Coastal Connections Conceptual Planning Study

APPENDIX A

CALIFORNIA COASTAL COMMISSION (CCC) STAFF REPORTS, DEL MAR BLUFFS STABILIZATION PROJECT PHASES 4 & 5

Consistency Certification No.: CC-0004-18

Figure 2 – Soil Cement Buttress

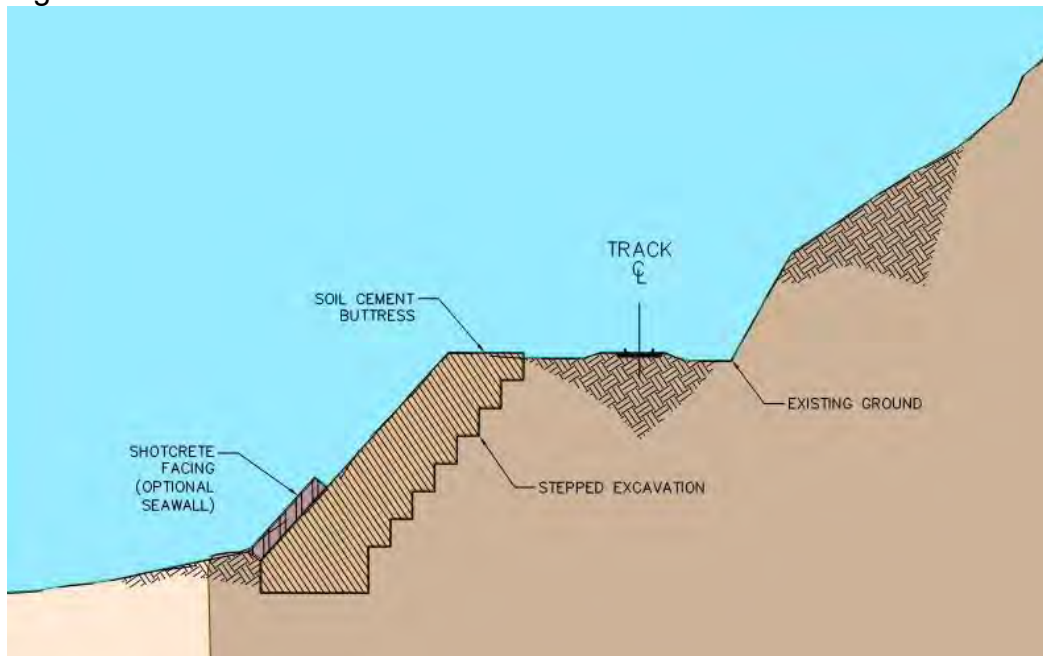
Although this design would eliminate the need for additional pilings and tieback anchors at the top of the bluff, the entire bluff face would need to be removed and replaced with soil cement. Soil cement is a more cost-effective approach to bluff stabilization, but once the tracks are relocated the soil cement would require significant engineering and disturbance to the bluff face to remove. Finally, construction of the soil cement buttress would not eliminate the need for shotcrete facing or a seawall to protect the toe of the slope from erosion. As such, the soil cement buttress alternative would require greater disturbance to the bluff face to construct, would still require toe protection that would encroach upon the public beach, and ultimate removal would be more difficult and destructive to the bluff face compared to the proposed upper bluff work in conjunction with seawalls.

Figure 3 – Soil Nail Reinforcement

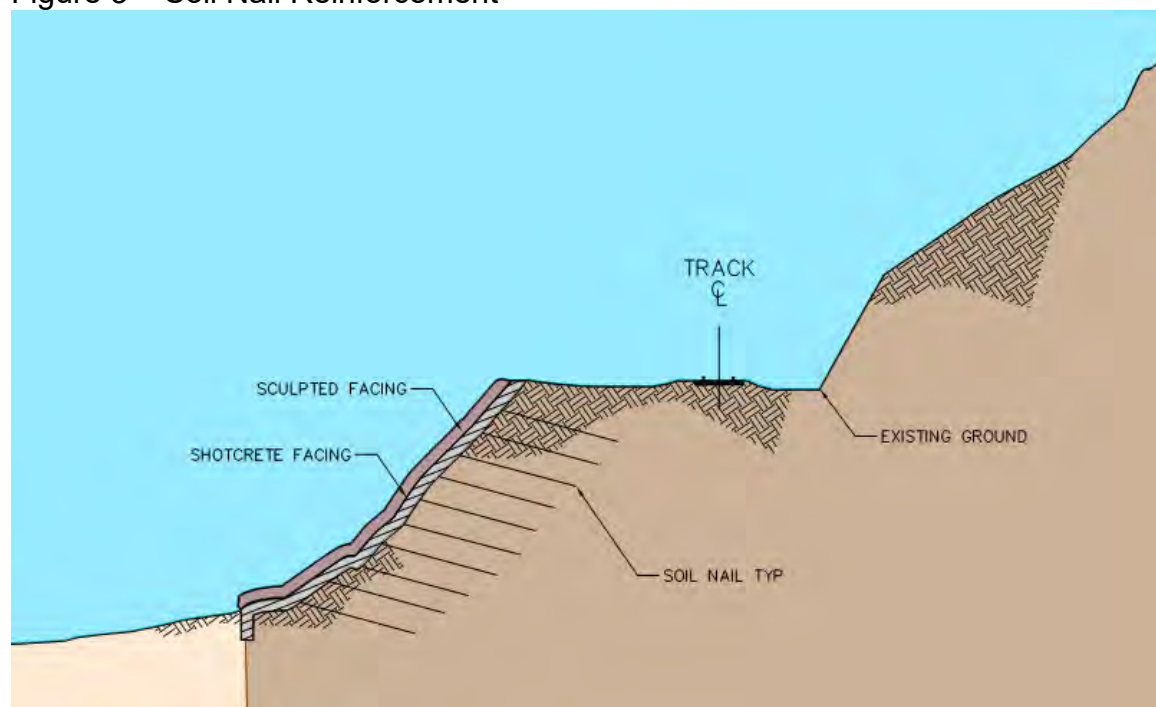
Similar to the cement buttress alternative, this design would eliminate the need for additional pilings and tieback anchors at the top of the bluff. However, the entire bluff face would need to be covered in concrete or shotcrete for adequate stabilization. Once the tracks have been relocated the removal of the shotcrete facing would not be difficult, but because the soil nails are grouted into the bluff face their removal would require complete excavation which would result in significant disturbance to the bluff face. The soil nail alternative would require greater disturbance to the bluff face to construct, would still require surface stabilization, and ultimately removal would be more difficult and destructive to the bluff face.

Figure 4 – Emergency Repairs at MP 245.2

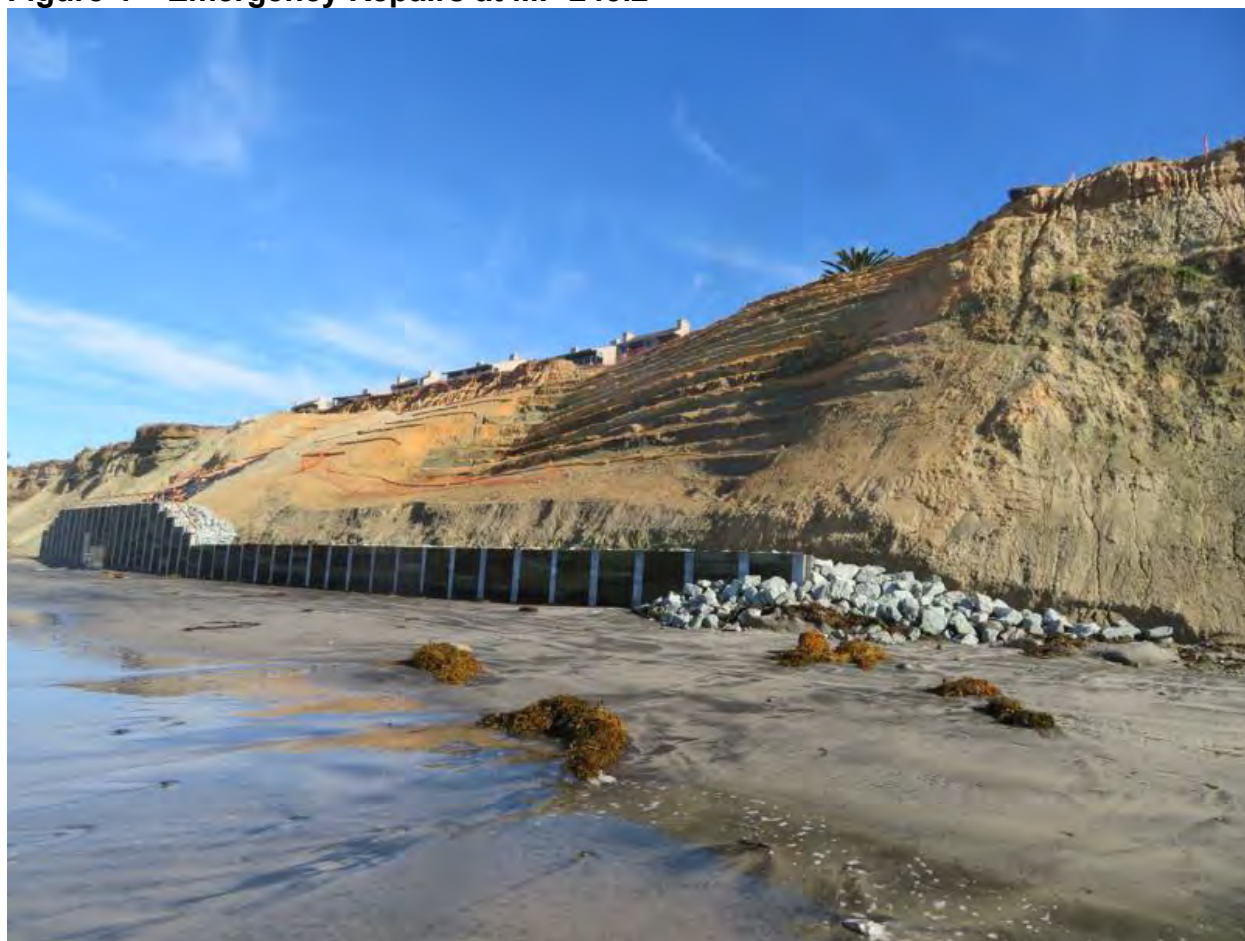
As demonstrated in the figure above, the bluff grading and installation of a new seawall and rip-rap end protection that was carried out as part of the emergency repairs at MP 245.2 resulted in significant alteration of the natural bluff landform and beach and is not visually compatible with the existing character of surrounding natural areas. The

Figure 1 – Typical Section of a Stabilization Improvement Area

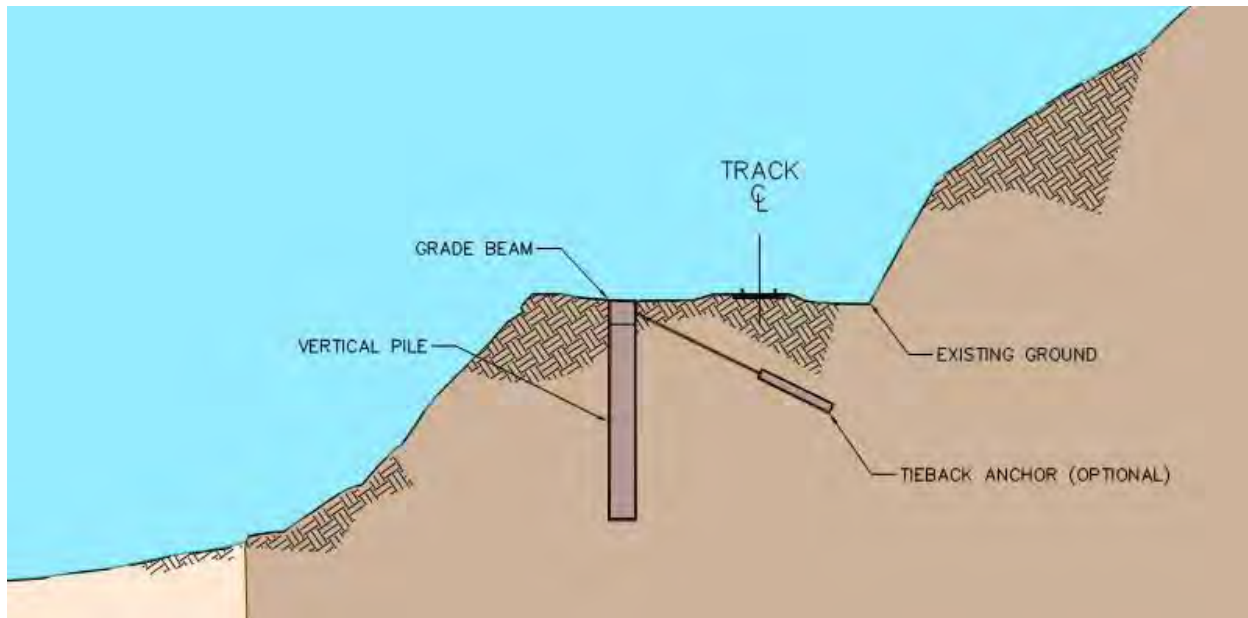
The amount and depth of piles, number of anchors and depth of lagging would be specific to the geotechnical and engineering requirements of each stabilization area, but

Figure 4 – Typical Section of a Seawall

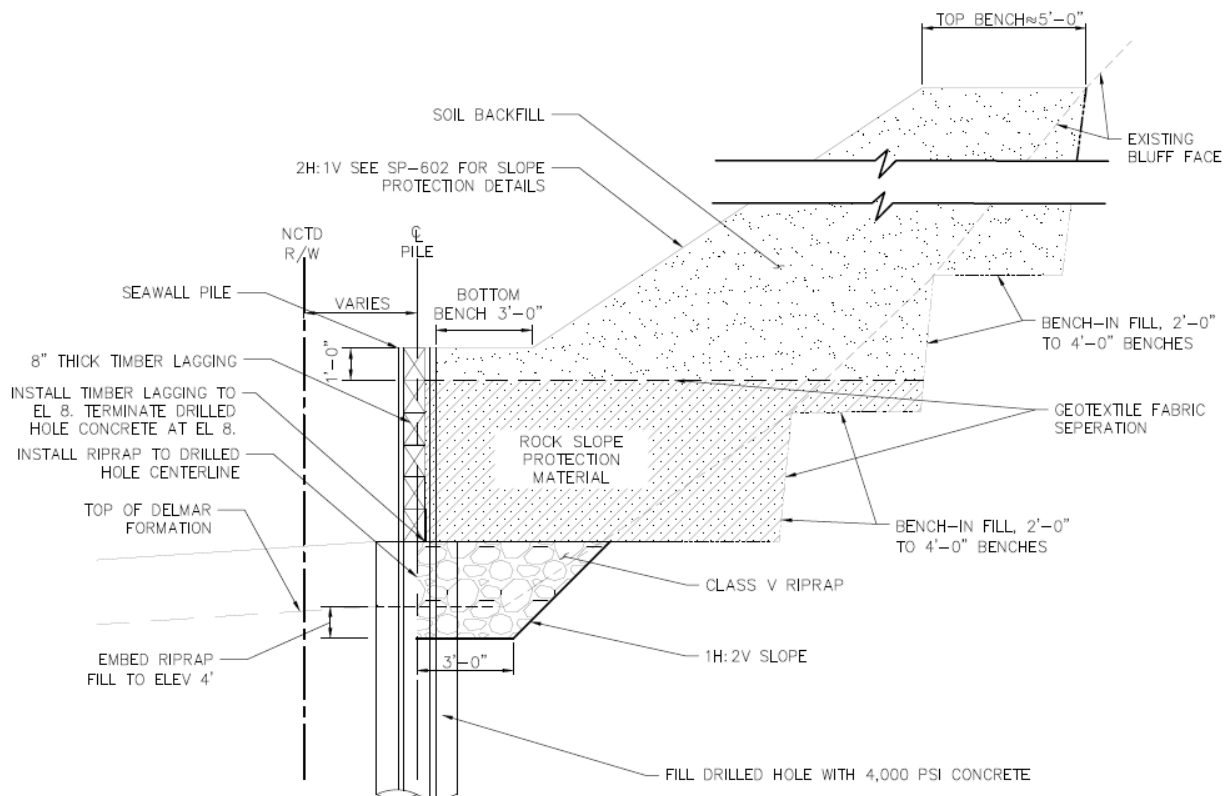
In total, the project proposes 6 new seawalls ranging in length from 48 feet to 814 feet with a total combined length of 2,151 linear feet. The seawalls would generally be interspersed throughout the project area beginning at Seagrove Park in the upcoast area of the project site and ending near Anderson Canyon, as illustrated in **Exhibit 4**, and the distance between the seawalls and the bluff face would vary from immediately adjacent to upwards of 26 feet seaward depending on the shape of the bluff. The height of the seawalls with respect to the beach and sand level would vary throughout the year, but at a proposed elevation of 15 feet above MSL, the top of the walls would be approximately seven feet high from the ocean side. The rip rap placed being the seawalls would be Class V with individual pieces of rock ranging in diameter between 15.5 and 36 inches. On top of this rip rap, SANDAG proposes to place soil fill material to achieve a slope ratio ranging from 5:1 to 2:1 from the top of the seawall to approximately the middle of the bluff height. This fill would be placed to catch the slope and mid-bluff and provide added support against slumping or failure. This approach was developed by SANDAG as an alternative to grading and removal of material from the entire bluff face.
